Western Star 47X/49X Front Suspension Threaded Bushings

FIELD SOLUTION: TSB or updated SS734 WST

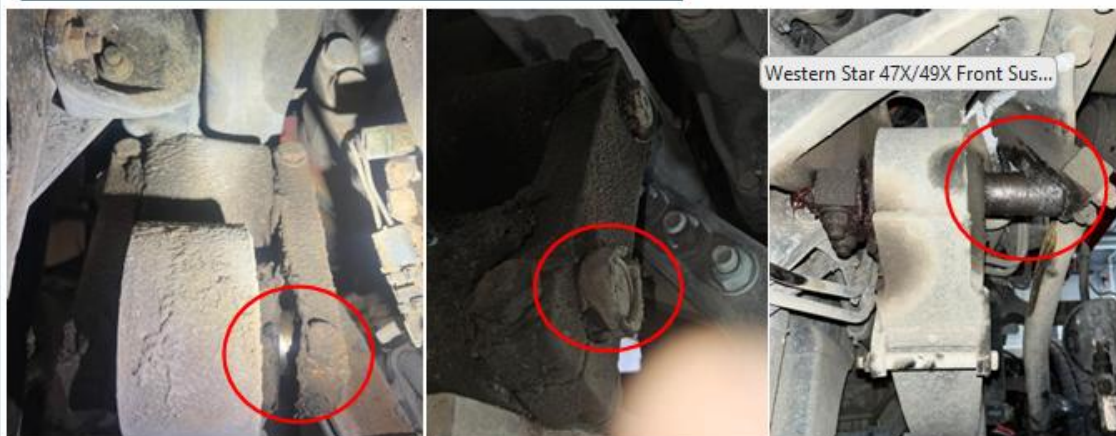
- WST threaded bushings can bind/seize and move laterally within front spring eye/shackle bracket. Drivers report audible popping noise during turning events.

- Planned changeover to graphite bronze bushings on flat leaf springs pushed to Q1 2027
- Supplier lead times for shackle brackets and inclusion of twin-steer specific components

- 02/2027 changeover to graphite bronze bushings
- Taperleaf springs with threaded bushings have been blocked since June 2023. HD Rubber bushings only.

- Three resolution paths:
 - Taperleaf springs offered only with HD rubber bushings (STCA) June 2023
 - Flat leaf springs offered with graphite bronze bushings (MTCA)
 - Engineering to develop new vocational bushing to replace graphite bronze bushing (LTCA)
